GROUP FUE	MODEL 2012-2017MY Rio (UB)
	NUMBER 040	DATE April 2018
TECHNICAL SERVICE BULLETIN		
SUBJECT: CANISTER CLOSE VALVE (CCV) REPLACEMENT

CANISTER CLOSE VALVE (CCV) REPLACEMENT

Canister Close Valve
(CCV)

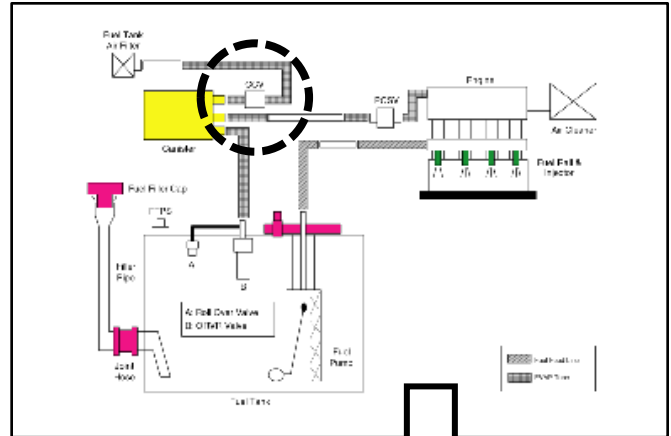
This bulletin provides the procedure to replace the Canister Close Valve (CCV) on some 2012-2017MY Rio (UB) vehicles, produced from June 21, 2011 through March 28, 2016, which may exhibit the engine warning lamp DTCs P0455 and P0456 for an evaporative emission system leak due to the Canister Close Valve (CCV) stuck open. Follow the procedure outlined in this bulletin to replace the CCV with an improved part. Before conducting the procedure, verify that the vehicle is within the affected production date range.

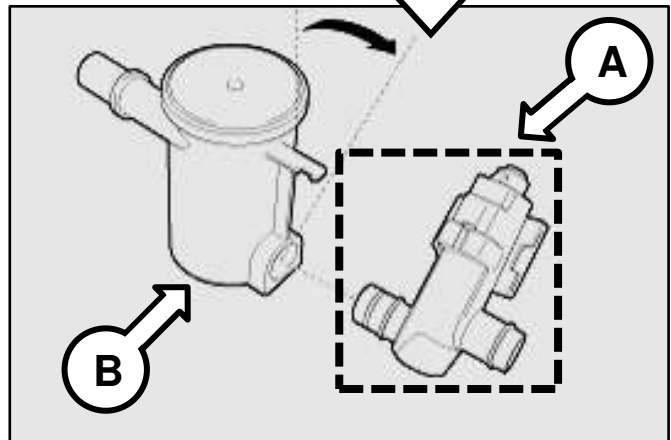
The Canister Close Valve (A) is a separate part from the Fuel Tank Air Filter assembly (B) where it is inserted.

Improved CCV: Rubber seal material change and port color change (black to tan) as shown.

1. Replace the Canister Close Valve (A) by referring to the “Engine Control / Fuel System → Engine Control System → Canister Close Valve (CCV) → Repair procedures” chapter in the applicable Shop Manual on KGIS.
